SITE PLAN & ARCHITECTURAL  
COMMISSION  
AGENDA  
DECEMBER 6, 2019

50.1 **AC-19-062** Consideration of the construction of a 37,652 square foot, four-story hotel (My Place Hotel) on 1.9 acres located at the southwest corner of Airport Road and Biddle Road in the C-R (Regional Commercial) zoning district (372W12A1102). Applicant, MP Medford LLC; Agent, Ausland Group; Planner, Dustin Severs.

for a Type-III quasi-judicial decision: Site Plan & Architectural Review

**To** Site Plan and Architectural Commission *for 12/6/2019 hearing*

**SITE PLAN**  
 SCALE: 1" = 20' (AS SHOWN)

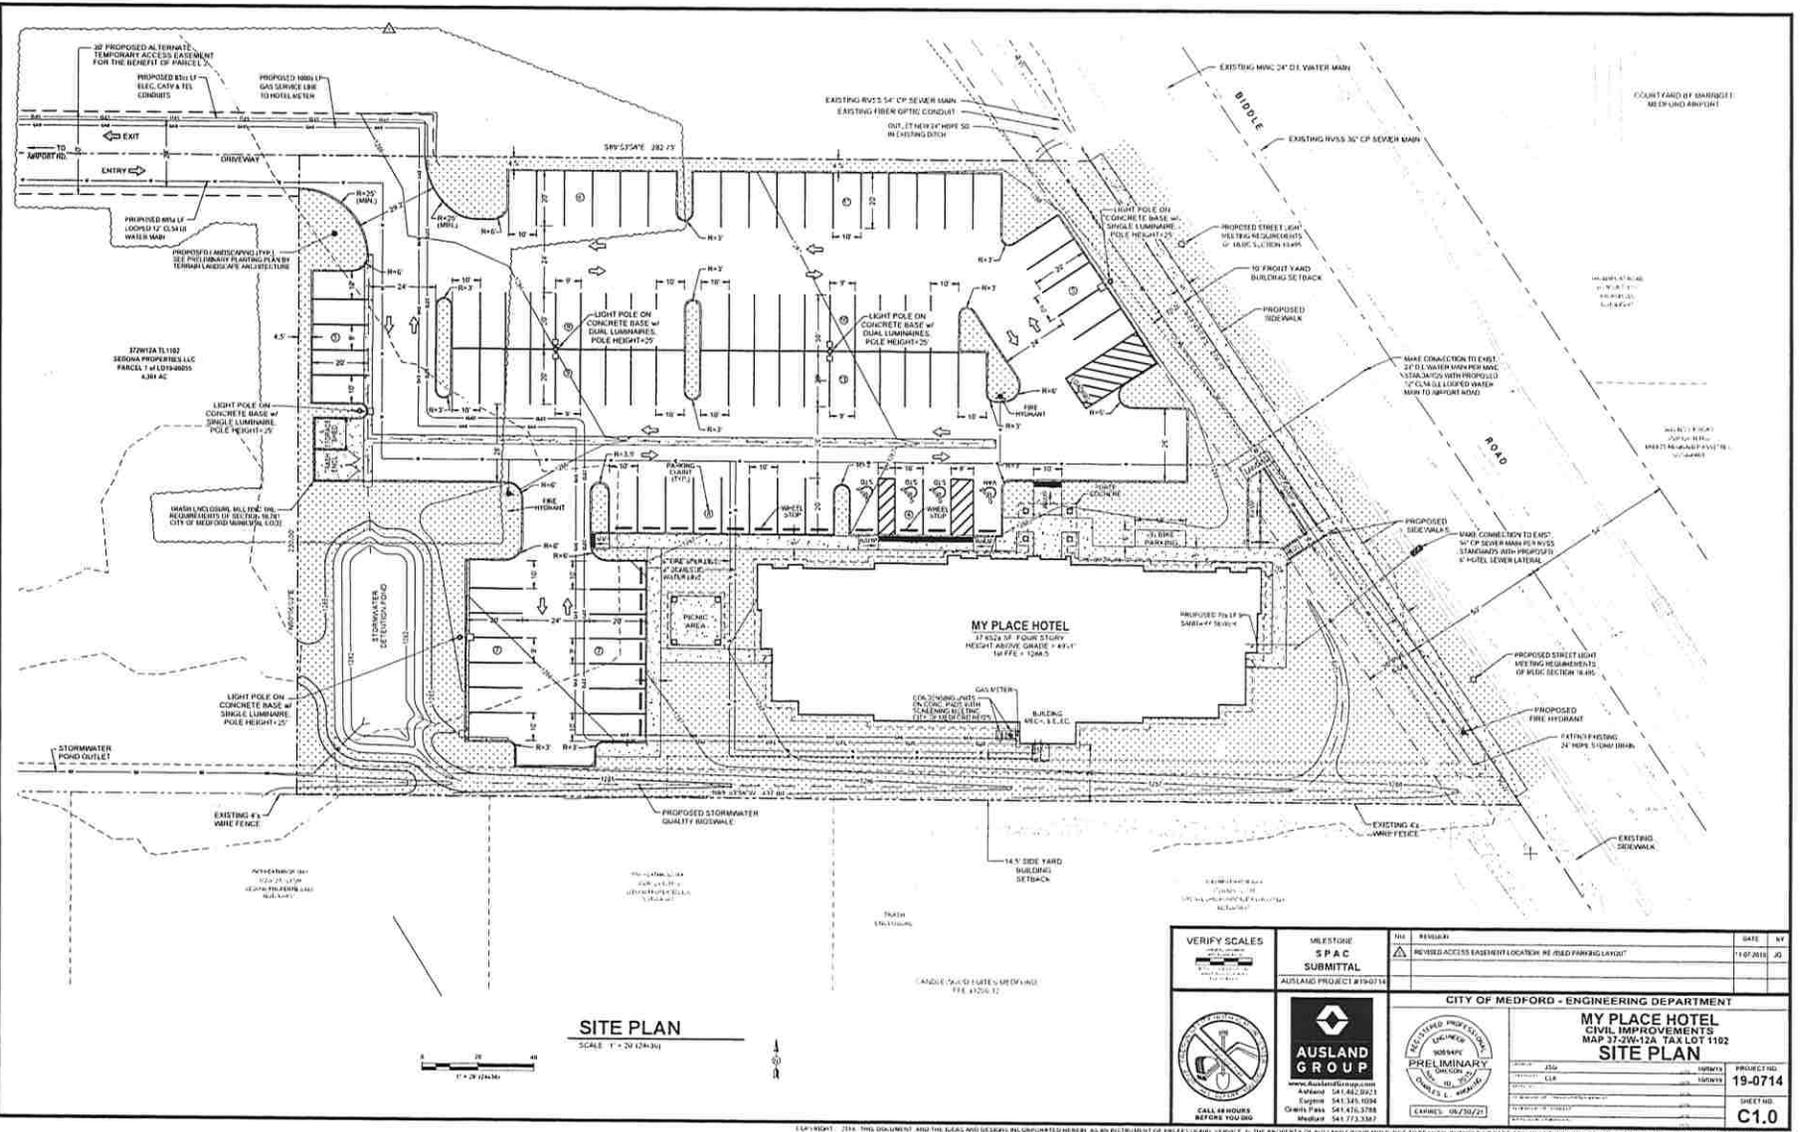
The submitted site plan shows a total of 92 parking stalls, along with four handicap spaces and nine bicycle spaces. The 92 proposed spaces, however, exceed the maximum allowed as per MLDC 10.743-751. The applicant has requested relief from the Code in order to exceed the maximum number of parking stalls by five spaces.

The site plan shows a pedestrian walkway connecting the proposed building to the public sidewalk running along the site's frontage with Biddle Road; however, the site plan does not show pedestrian connectivity to the abutting parcels to the north, south, and west.

The subject site abuts vacant property along its north, south, and west boundaries. In the interest of promoting pedestrian connectivity with the abutting undeveloped lands—consistent with MLDC 10.773(2) cited above—it is staff's view that the site plan should include pedestrian walkways stubbed at all three boundaries, providing the abutting lands the ability to connect their own internal pedestrian circulation to the subject site at the time they are developed in the future.

1. Provide staff with documentation proving legal access off of Airport Road through the abutting property, as illustrated on the submitted site plan.

2. Comply with all conditions stipulated by the Public Works Department (Exhibit M).
3. Comply with all conditions stipulated by the Medford Water Commission (Exhibit N).
4. Comply with all requirements of the Medford Fire Department (Exhibit O).
5. Comply with all applicable requirements of Jackson County Roads (Exhibit P).
6. Comply with requirements of Rogue Valley Sewer Services (Exhibit Q).
7. Submit a revised site plan showing a single pedestrian walkway stubbed at each boundary of the site—north, south, and east boundaries—connecting the site's internal pedestrian circulation to the abutting undeveloped lands.
